From:	Leigh Hwa
To:	Donald Washburn
Cc:	Nikole CH. Coleman
Subject:	Re: Fw: Pinnacle at Liberty Bay - Revised Project Document Link
Date:	Saturday, November 7, 2026 11:35:26 PM
Attachments:	Outlook-mguwpi3t.png Outlook-tumlfcmc.png

Re: Objection to Pinnacle at Liberty Bay Planned Residential Development and Preliminary Subdivision — Permit No. P-06-20-25-03

RE: Public Comment on Pinnacle at Liberty Bay PRD and Preliminary Plat & Preliminary Conditions of Approval (P-06-20-25-03)
Unlawful SEPA Segmentation, Improper Use of Optional DNS Process (WAC 197-11-355), and Objection to Unanalyzed Connector Road from Proposed PRD Through Baywatch Ct NE to SR 305.

Re: Dana and Katharine Lockhart's Comments on Pinnacle at Liberty Bay Planned Residential Development and Preliminary Plat, File No. P-06-20-25-03

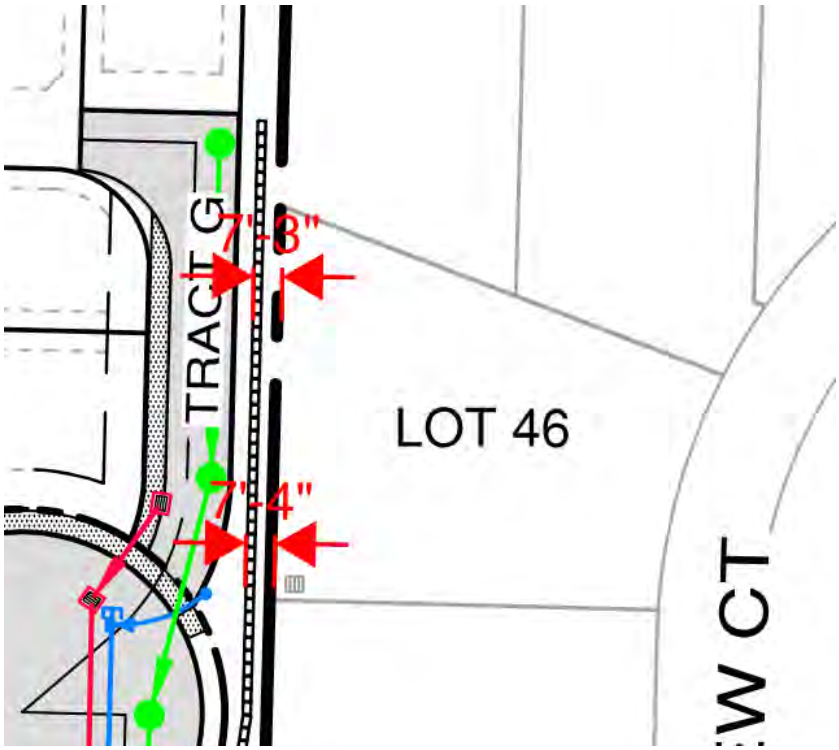
You confirmed on November 3 that Section G-G represents the fill-style retaining wall proposed directly west of Lot 46. However, the site plan shows the Tract G wall only 7 ft 3 in to 7 ft 4 in from my property line, rather than the 15 ft shown in Section G-G.

1. Tract narrowing — which controls? Figure 1, Section G-G (ESM narrative, September 16, 2026) labels a 15-ft tract to the project boundary, but your site-plan measurements show 7'-3" and 7'-4" from the wall to the Lot 46 lot line. Has the tract been narrowed from 15 ft to 7 ft 3 in to 7 ft 4

> Good Morning Leigh,
>
> I received an email from you regarding some questions on Pinnacle at Liberty Bay. You are correct that cross section G-G is the style of fill being proposed directly to the west of lot 46 on Crystal View.
>
> On the most recent site plan for Pinnacle at Liberty Bay, it appears the face of the proposed wall in that tract (Tract G) is around 7ft from the Crystal View Lot 46 lot line.

> Good morning Leigh,
>
> As I'm sure you're already aware, these site plans are purely conceptual at this stage. The placement of retaining walls on these drawings is more of a preliminary concept rather than a final approved construction plan. The infrastructure and drainage systems associated with retaining walls would be evaluated and reviewed during our Civil Grading Permit review, which is entirely separate from our Land Use review. The Geotechnical Addendum from the applicant dated June 17, 2026 indicates that retaining walls of up to 20 feet in height may be used to accommodate grade changes throughout the site.

It certainly does appear that Tract G is narrowed further to the north. I'm unclear what the reasoning is for the narrowed tract in that portion of Tract G. One possibility would be that the wall type in that area requires less buffer than other larger retaining walls on site.

As of this email, we have no indication that MSE reinforcement is being proposed for the walls on Tract G. If MSE reinforcement were to be used, the entire wall system would need to be contained within the project boundary. We wouldn't allow MSE reinforcement on private property.

SECTION G-G

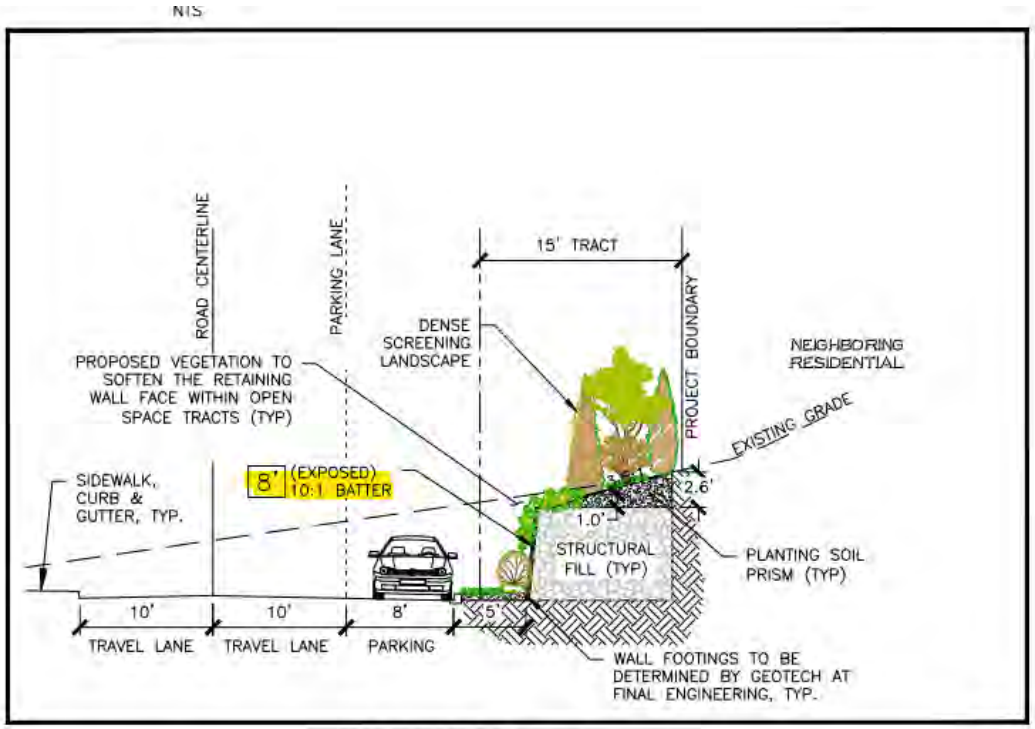
In Exhibit 3.b, Section G-G describes the wall construction as "structural fill (TYP)." Based on this, I would therefore expect similar structural fill and reinforcement to be incorporated into the retaining wall design.

Given that the wall height remains approximately 8 ft, as indicated in Section G-G, while no MSE reinforcement is identified for Tract G, I am concerned about how the proposed wall will achieve adequate structural stability.

Looking at the details for section G-G, it appears that the wall height being proposed in this section is 8ft.

Take the wall next to Crystal View as the example. Exhibit 3.b, Section G-G, shows an 8-foot wall, a 15-foot tract, and construction as "structural fill (TYP)." But City Engineering confirmed the Tract G wall is different from what Section G-G shows. The wall is only 7 ft 3 in to 7 ft 4 in from the neighboring property line, not 15 feet. The tract was narrowed, with no explanation. And no MSE reinforcement is indicated for Tract G, even though the wall is still 8 feet high.

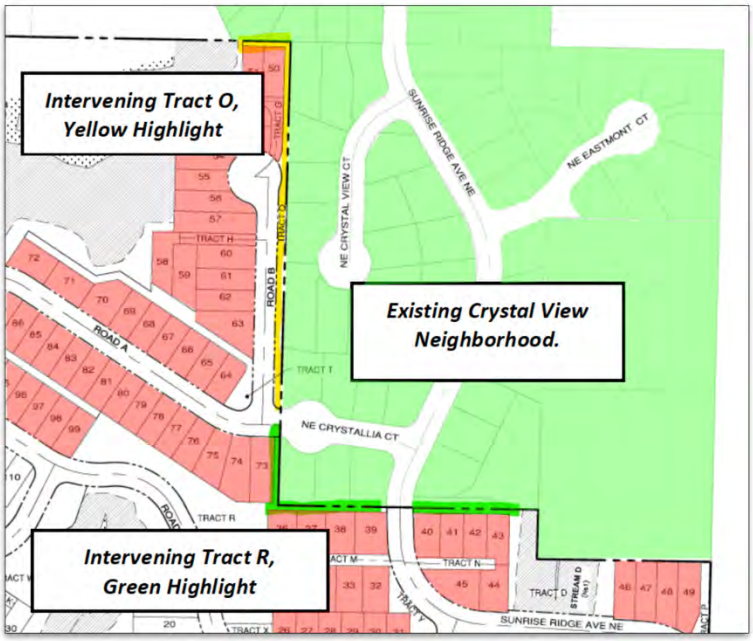
It does not take an expert to recognize the stark lack of consistency between the proposed Pinnacle PRD and the existing Crystel View subdivision. And although the Staff Report notes that consistency has many factors, it cannot be disputed that when the Poulsbo City Council adopted the consistency requirement at PMC 18.260.070.A, that code section was drafted specifically with a focus on consistency between lot sizes and dimensions. Matching lot sizes and dimensions may be a subset of conditions authorized by PMC 18.260.070.A for achieving consistency, as the Staff Report observes. But there can be little doubt that those were the most important considerations when this code section was adopted, as evidenced by the Council's express reference to them in the plain language of the rule. It is likely for this reason that consistency between proposed and existing lot sizes (either in absolute square footage, or linear feet along the project boundary) has consistently been a prime consideration in prior City PRD staff reports, such as in the staff reports for the Calavista PRD (Planning File P-05-8-19-01), the Cedar View at Glenwood PRD (Planning File P-11-04-25-02), and the Noll Pointe PRD (Planning File P-09-10-25-01). The City's Staff Report for the Pinnacle PRD breaks markedly with that pattern of practice by effectively ignoring the lot size issue altogether, conflicting with the public's interest in consistent and predictable application of the code.

Thus, we would request that the Planning Commission either (a) recommend denial of the proposed Pinnacle PRD due to a lack of consistency within the meaning of PMC 18.260.070.A, or (b) impose a condition requiring Pinnacle Lots 50 through 64, 73, 36 through 39, and 40 through 43 (i.e., the perimeter lots as shown at Sheet PP-01 of Staff Report Exhibit 2.b) to be increased to a size more consistent with the adjacent lots in Crystal View. Consistency may be multi-factored. But that does not mean lot size can be ignored, as it is obviously within the central focus of the rule. The rule also requires consistency, not "partial consistency."

Figure 1: Proposed Layout for Sunrise Ridge Ave NE

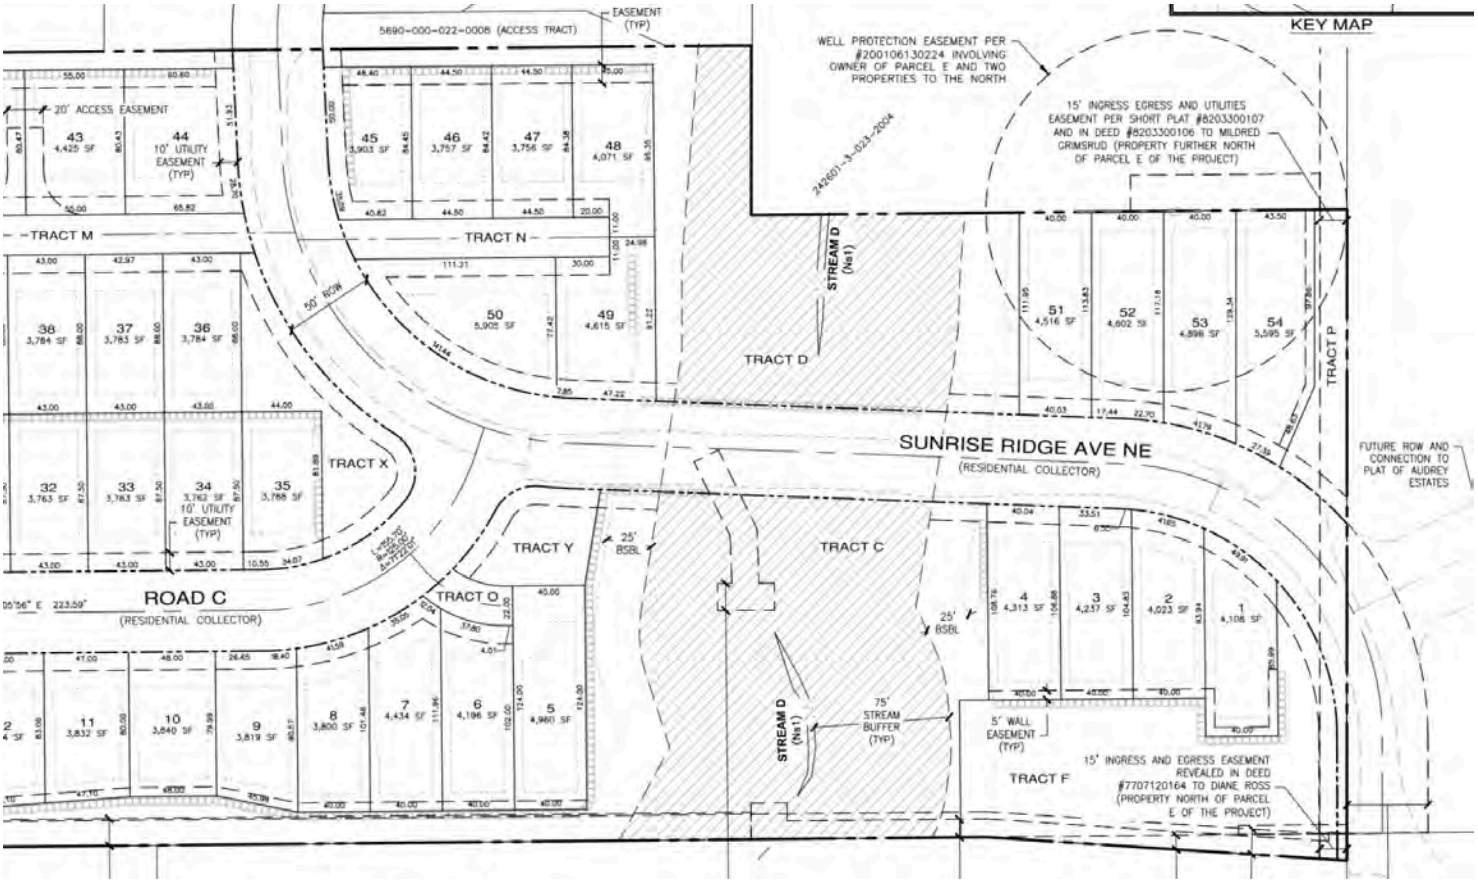
The proposed layout for Sunrise Ridge Ave NE follows the existing maintenance access road in the same location (figure 1). The new layout would increase the width of the roadway to the extent possible within the right of way (ROW) including a single vehicle lane in each direction and sidewalks on either side of the street. There are roadways connected to the proposed layout of Sunrise Ridge Ave NE to provide access to homes within the development. Additionally, residential plots are proposed having direct access to Sunrise Ridge Ave NE.

Due to the nature of the topology in the area and the steepness and curvature of the roadway, the sight distance may be obstructed within the 135 feet stopping sight distance (figure 3). Additionally, drivers leaving Tract N may not have sufficient time to make a maneuver onto Sunrise Ridge Ave NE.
